TOWN OF SOUTHEAST
PLANNING BOARD/ARCHITECTURAL REVIEW BOARD AGENDA

March 23, 2026

Memorandum

To: Town of Southeast Planning Board
From: AKRF, Inc.
Date: March 17, 2026
Re: Rraci's Starr Ridge Road
cc: John M. Watson, PE

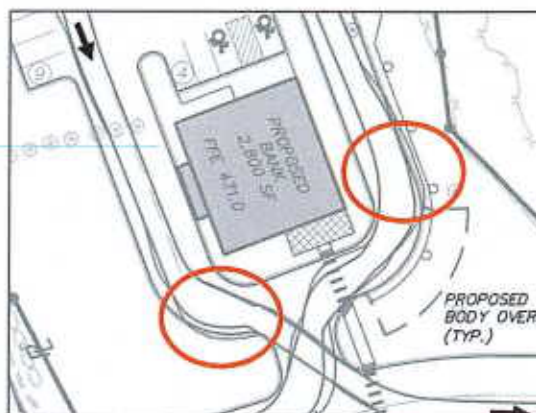
9/23/25: Drawing VM-1, "Vehicle Maneuvering Plan" has been provided to illustrate fire truck maneuvers onsite. The drawing shows that the path of an aerial fire apparatus would conflict with curbing at the driveway to the proposed drive-thru. If the proposed drive-thru use remains, the curbing should be modified to accommodate truck movements.

3/17/26: Comment not addressed. The below excerpts from sheet VM-1 indicate potential conflict with the proposed Route 6 driveway pork chop island and curbing for the drive-thru driveway. The curbing should be modified to accommodate fire truck movement. In addition, the Applicant should confirm whether the roadway grades (in excess of 10%) have been reviewed by the fire department.

Figure T-1 – Turning Moving Analysis, prepared 3/17/26.

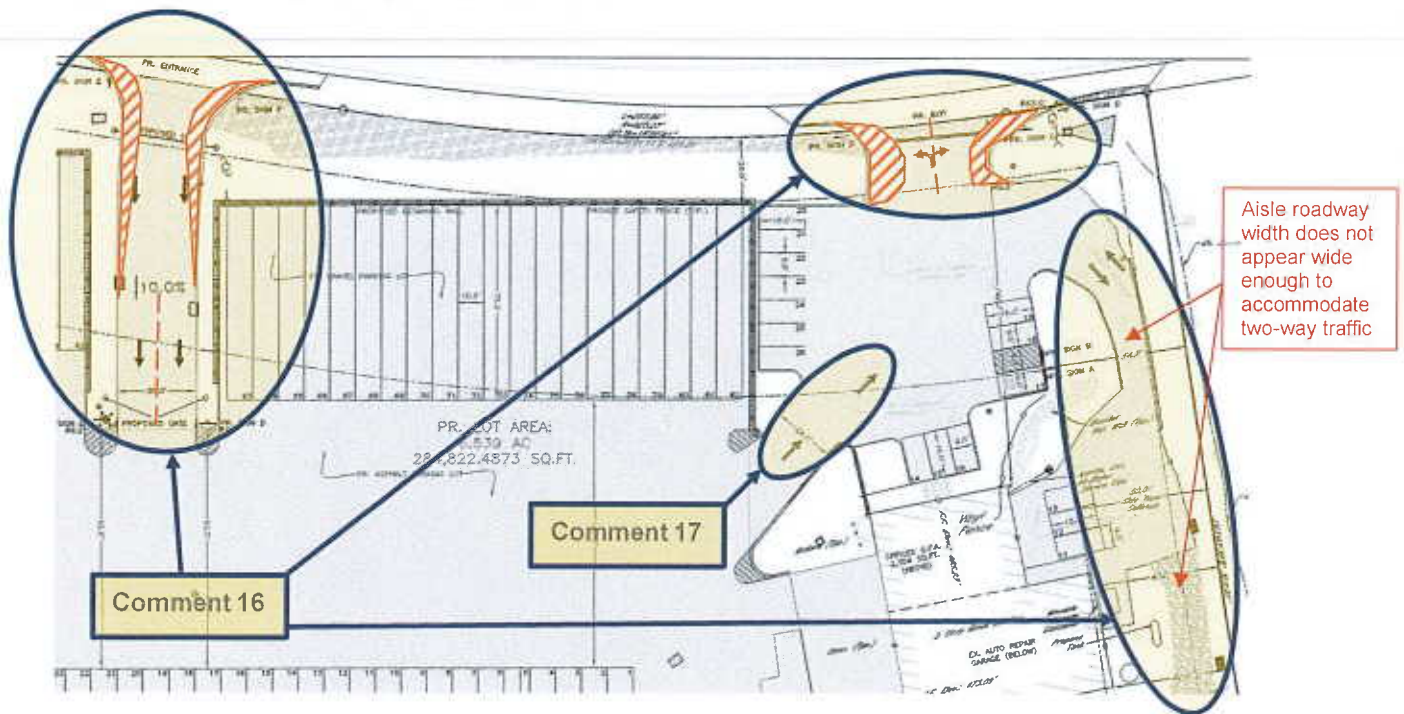
space for tractor trailers to perform required turning maneuvers safely. In addition, the aisle along the northern perimeter of the site has pavement markings designating two-way traffic flow; however, there are sections of this aisle (both paved and gravel) that do not appear to be wide enough to accommodate two-way traffic. See Figure T-1, below (following Comment #17).

3/17/26: Comment partially addressed. The site plan (Sheet 2) shows the location of signage and pavement marking, and sign details are provided on Sheet 8. (Note, Sheet 8 labels two signs as "Sign A." It appears that the "No Parking Anytime" sign is incorrectly labeled as "Sign A" and should be "Sign B". This should be corrected.) The traffic flow directional arrow pavement markings in the vicinity of parking spaces 14 through 26 designate one-way northbound traffic flow on Sheet 2 ("Layout Plan") of the site plan set, but the truck turning path drawings (TT-01 through TT-04) show traffic flow directional arrow pavement markings that designate two-way traffic flow in the same area. The traffic flow directional arrow pavement markings should be consistent across all drawings throughout the site. See Figure T-1, below.
